DOCKET NUMBER 50-483
CALLAWAY PLANT
UNION ELECTRIC COMPANY
REVISION TO TECHNICAL SPECIFICATION 5.5.9
"STEAM GENERATOR (SG) TUBE SURVEILLANCE PROGRAM"
References: 1) ULNRC-04745 dated October 3, 2002
2) NRC letter to G. L. Randolph dated February 4, 2003

2 copies of LTR-SGDA-03-129, "Responses to NRC RAIs on Partial-Length RPC Inspection of the Tube Sheet Region of the Callaway Plant Steam Generators" (Proprietary)

REQUEST FOR ADDITIONAL INFORMATION
RELATED TO STEAM GENERATOR TUBE INSPECTION LICENSE AMENDMENT
UNION ELECTRIC COMPANY
CALLAWAY PLANT, UNIT 1
DOCKET NO. 50-483

Figure Q65-1
 Callaway Non-axial Tubeshet Indications (Below -0.3" from TTS)

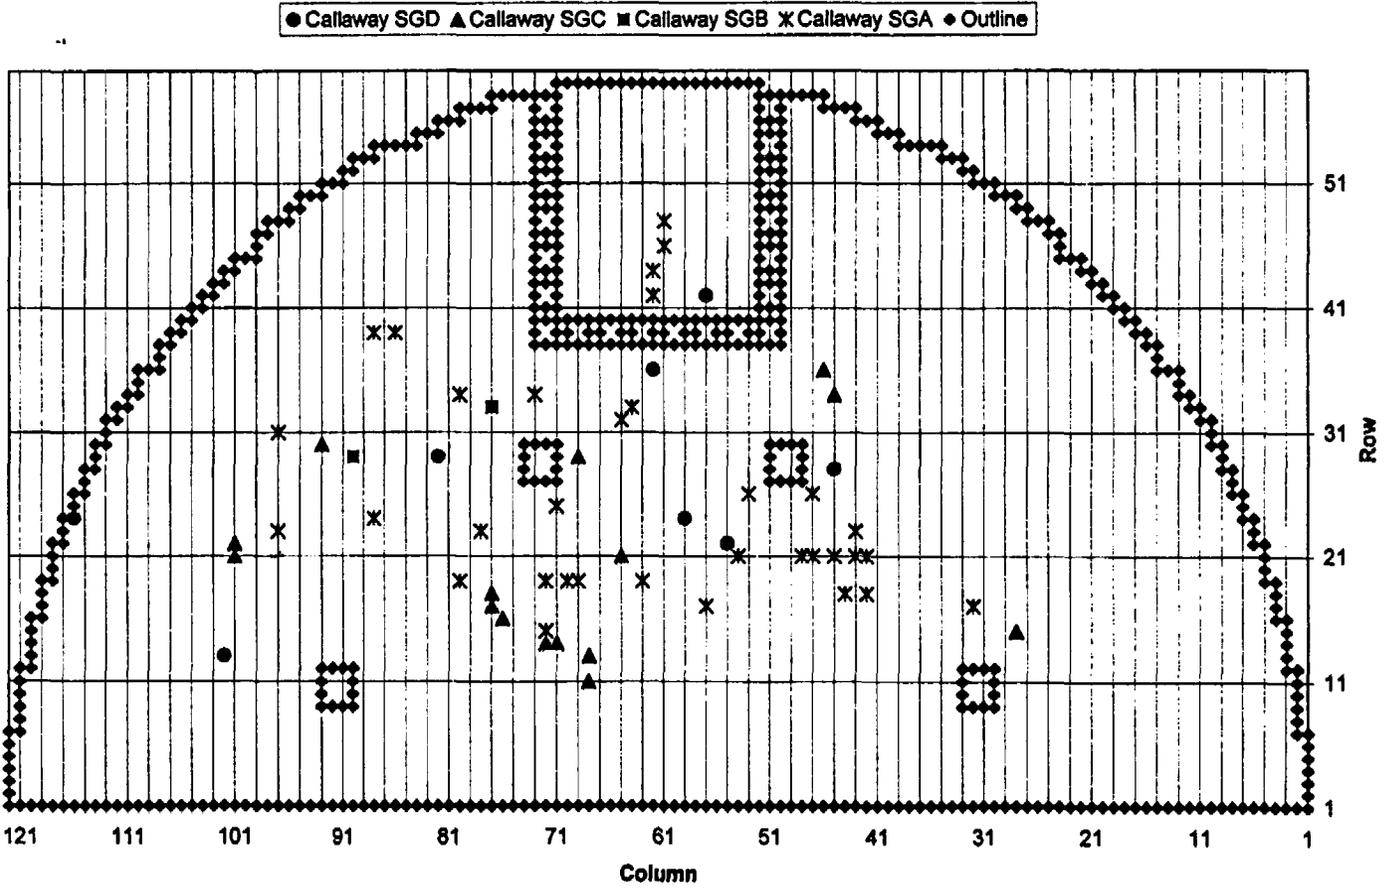
65. Regarding Figure 14 in the Westinghouse report, SG-SGDA-02-47, and the determination of the distribution of indications below the inspected region, it is not apparent that the methodology presented supports the conclusion that the distribution of indications below the H distance is uniform, for the following reasons:*

Replot Figure 14 based on all indications (regardless of severity, zone, or outage in which they were detected) and also with all indications in specific zones to assess whether the uniform distribution assumption still holds.

A tubesheet map of Callaway non-axial tubesheet indications below -0.3 inches from the top of the tubesheet is provided in Figure Q65-1. The plot supports a determination that the indications are distributed uniformly in the radial direction outside the thermally treated portion of the tube bundle and part of Zone A. Figure 6.14, "Distribution of Severe Indication Locations" of WCAP-15932, Rev. 1 supports a uniform distribution along the elevation of the tubesheet.
